HISTORIC AND DESIGN REVIEW COMMISSION

November 04, 2020

HDRC CASE NO: 2020-471
COMMON NAME: 335 TRAIL
LEGAL DESCRIPTION: NCB 6078 BLK 2 LOTS 9 THRU 14 & 17 THRU 20
ZONING: MF-33, H, RIO-1
CITY COUNCIL DIST.: 1
DISTRICT: River Road Historic District
APPLICANT: David Morin/MNO Investments
OWNER: David Price
TYPE OF WORK: Consideration and action of an application for a multi-unit residential development:

Item B: The applicant is requesting a Certificate of Appropriateness for approval to construct a multi-unit residential development (21 units) on the vacant lot located at 335 Trail. The property features lots that are located within the River Improvement Overlay only, as well as those that are located within both the River Improvement Overlay and the River Road Historic District. The applicant has proposed for the residential structures to feature two, two and one half, and three stories in height. Access to the site will be provided from Trail Street and Huisache Street. This request includes revised parking, building design and building massing.

Site Plan

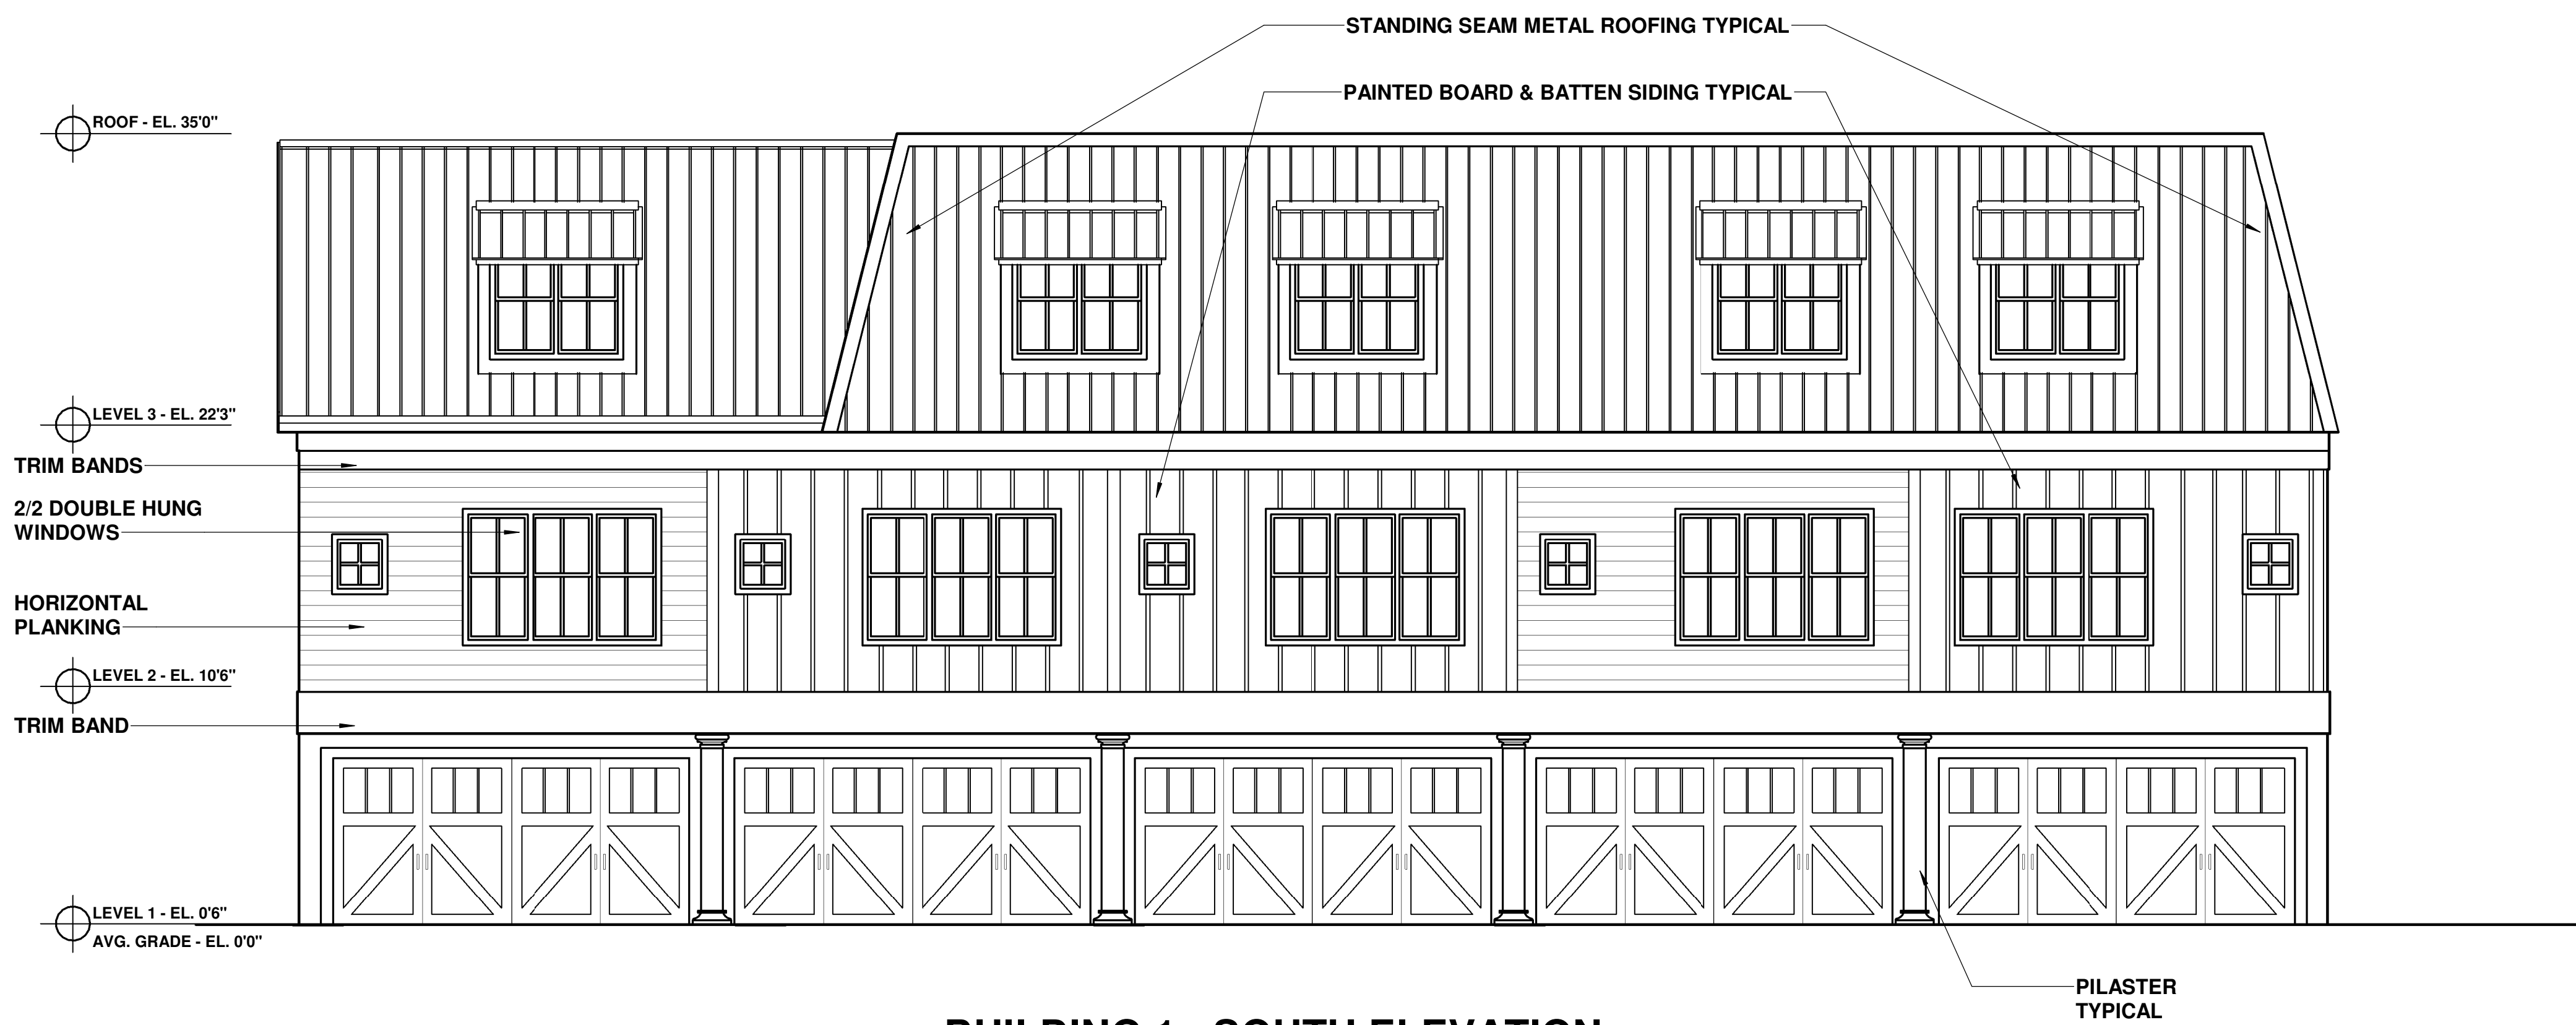
- r. **HUISACHE (Street widening)** – The applicant has proposed to widen Huisache Street by approximately four (4) feet within the public right of way and approximately two (2) feet on the vacant lot. The widening of the street will facilitate on street, parallel parking on Huisache; however, the widening of the street will also increase to total amount of impervious cover on site. Staff finds that all

areas of impervious pavement be considered for an alternative paving material that is consistent with Public Works standards.

- s. **PARKING ON TRAIL** – For units on Trail, the applicant has proposed driveways and parking to the west of each structure, comparable to the driveway configuration found historically throughout the River Road Historic District. The applicant has proposed ribbon strip driveways, but has not specified an exact width. Staff finds that a width of ten (10) feet should not be exceeded, per the Guidelines for Site Elements. The Guidelines for Site Elements 3.D.i. notes that mature trees and heritage trees should be preserved and protected. Staff finds that the driveway for third structure on Trail should be installed in a manner that does not negatively impact the heritage tree to the immediate north.

CF: The site plan should show clear setbacks.

- vii. That the applicant comply with all Public Works Department traffic requirements regarding emergency vehicle access, automobile access, storm water management and parking. Any resulting changes to the proposed site plan as a result of these reviews shall be submitted to staff for review and a Certificate of Appropriateness. Substantial an approved site plan may also require future HDRC review. New areas of pavement on Huisache must be pervious materials as allowable within Public Works standards.

ACEQUIA NOTES:

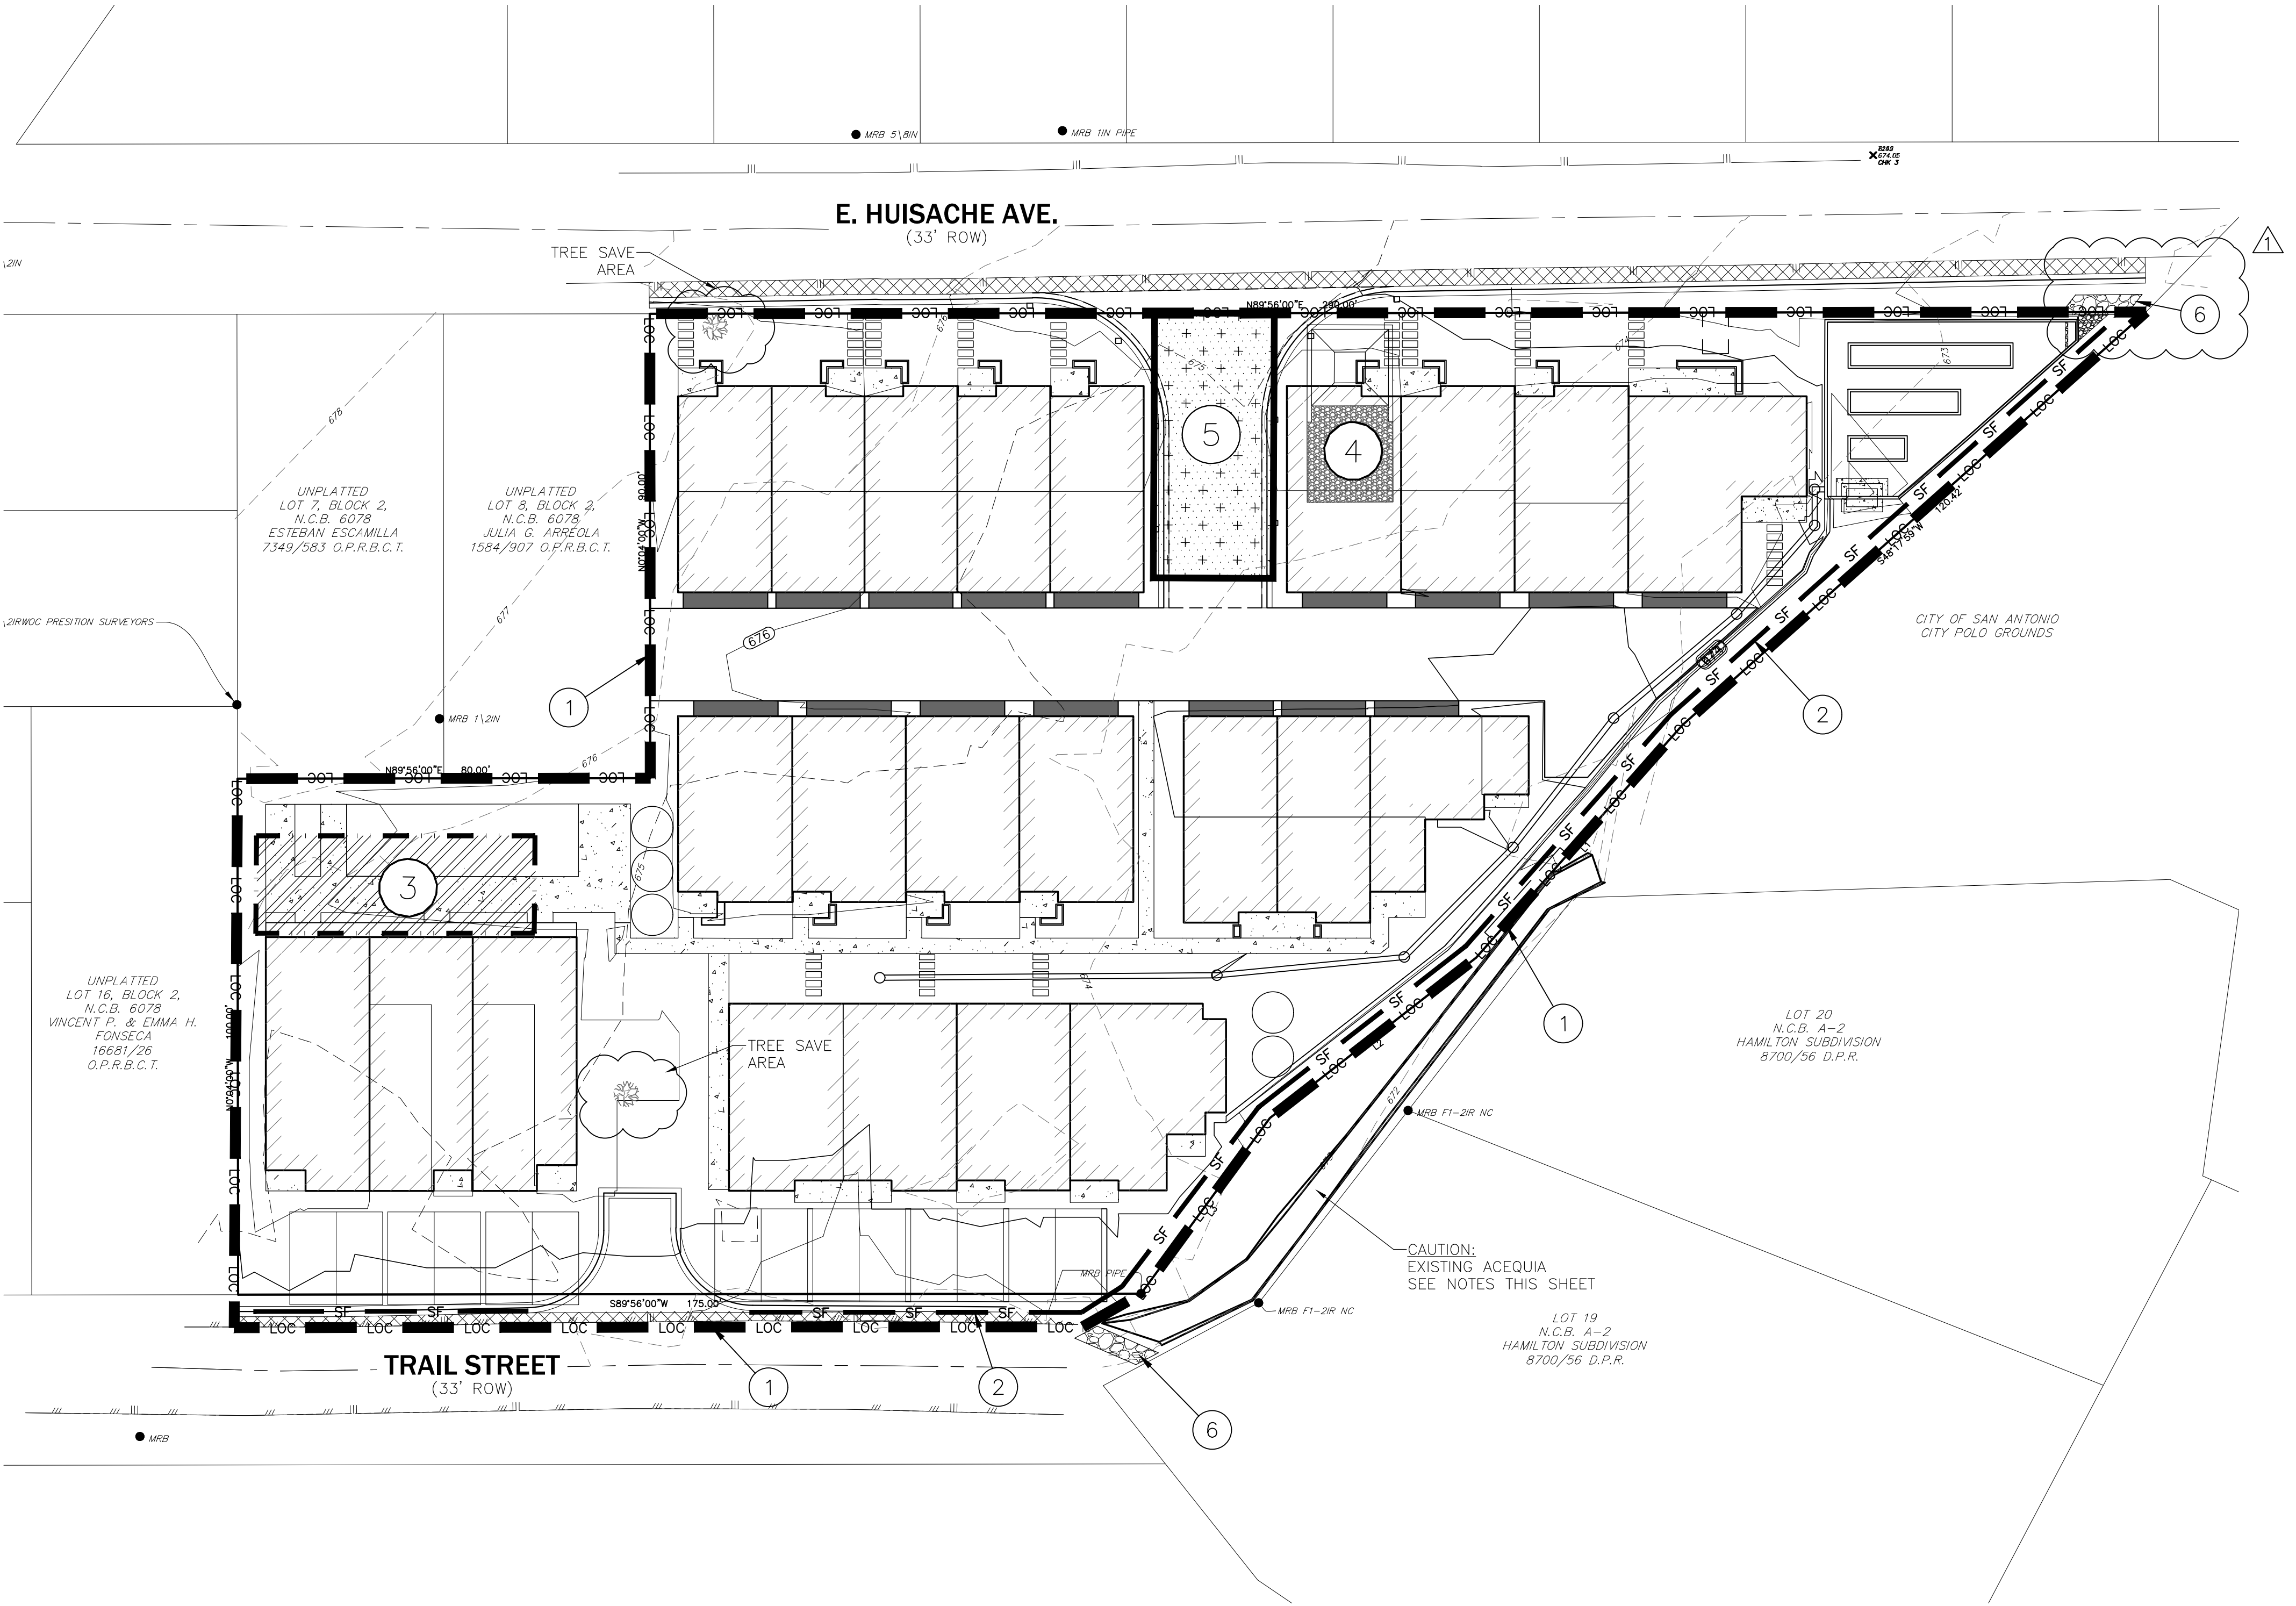
- l. **PROXIMITY TO ACEQUIA** – The applicant has proposed a setback of fifteen (15) feet from building 4 to the acequia, as well as a setback of more than fifteen (15) feet from building 6. While staff finds the increased setbacks to be appropriate; staff finds that additional steps must be taken to further protect the acequia. Staff finds that the applicant must submit a construction management plan. The construction management plan should outline the steps taken to protect the acequia throughout the course of construction. Moreover, the formal construction plans should identify no subsurface work (utilities, grading, etc.) within 5 feet of the extant acequia. In-field protection of the acequia should include orange construction fencing and silt fencing at a buffer distance of 5 feet from the feature. No construction activities will occur within the buffer area. This fencing should be present on-site until construction is completed. As stated previously, the acequia shall not be used for storm water drainage. Furthermore, the acequia shall not be used for storage, equipment cleaning, or any other use during development that could impact the feature.

- y. **ARCHAEOLOGY** – The archaeological investigation has been completed. The development project shall comply with all federal, state, and local laws, rules, and regulations regarding archaeology. Staff has general concern about the sensitivity of the site and the impacts of construction to the acequia. Detailed construction management plans should be developed and provided prior to permitting that includes the limits of construction in proximity to the historic acequia and measures taken to mitigate potential impacts during construction. The UDC Section 35-672 does not allow drainage into the acequia.

- ix. ARCHAEOLOGY – The archaeological investigation has been completed. The development project shall comply with all federal, state, and local laws, rules, and regulations regarding archaeology. The Upper Labor Acequia shall be preserved and shall not be impacted by new construction. Staff has general concern about the sensitivity of the site and the impacts of construction to the acequia. Detailed construction management plans should be developed and provided prior to final approval that includes the limits of construction in proximity to the historic acequia and measures taken to mitigate potential impacts during construction. The UDC Section 35-672 does not allow drainage into the acequia. Moreover, the formal construction plans should identify no subsurface work (utilities, grading, etc.) within 5 feet of the extant acequia. No construction activities will occur within the buffer area, **including but not limited to, a proposed walking trail and pergola**. In-field protection of the acequia should include orange construction fencing and silt fencing at a buffer distance of 5 feet from the feature. This fencing should be present on-site until construction is completed. As stated previously, the acequia shall not be used for storm water drainage. Furthermore, the acequia shall not be used for storage, equipment cleaning, or any other use during development that could impact the feature.

1. Window Section – Please see below. Windows will comply with historic design guidelines for trim, sill details, and installation depths.

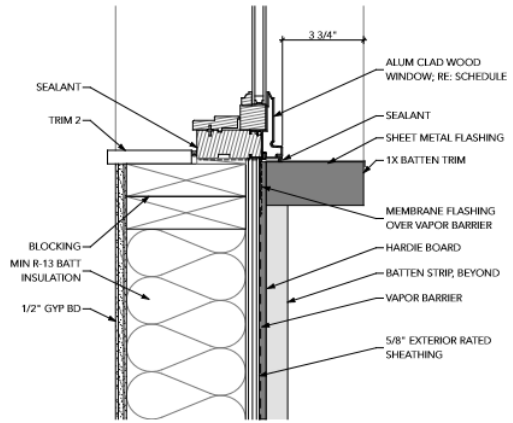
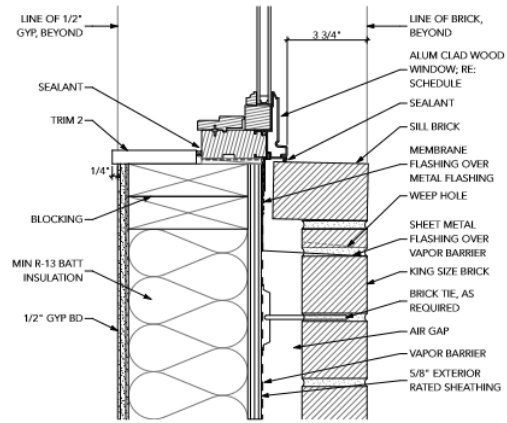
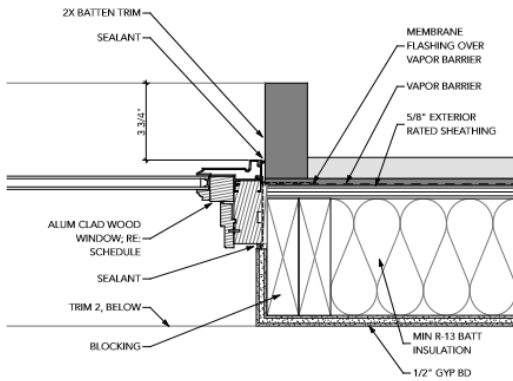
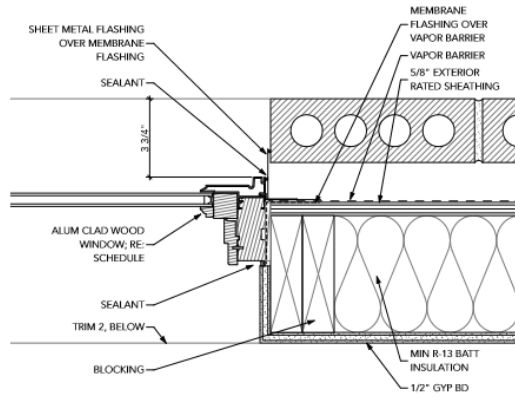
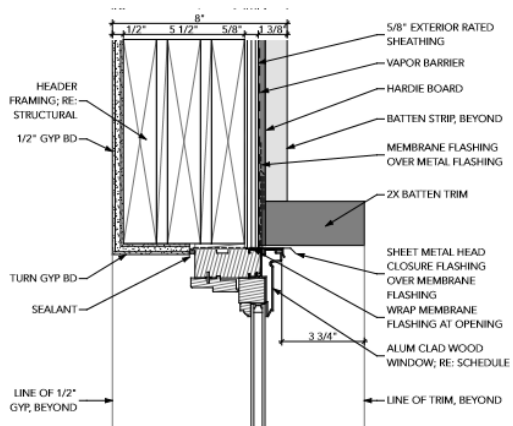
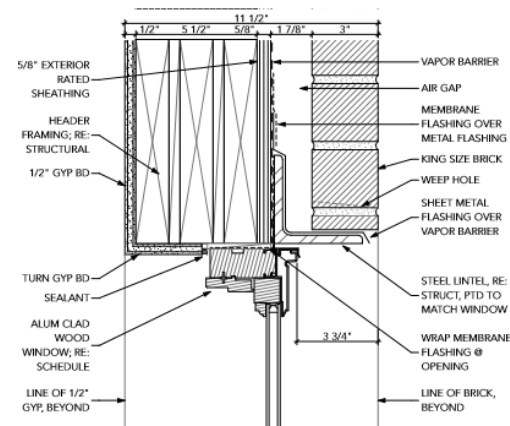
- o. **WINDOW MATERIALS** – Per the applicant’s submitted documents, an aluminum clad wood window is to be installed. Additionally, the applicant has submitted a window installation detail noting that windows will be sufficiently recessed within openings, per staff’s standards for windows in new construction. Staff finds that all standards for windows in new construction should be followed. These standards are found above in the applicable citations. The installation sections that the applicant has submitted are not consistent with staff’s standards in regards to installation depth, sill profiles, and trim profiles.
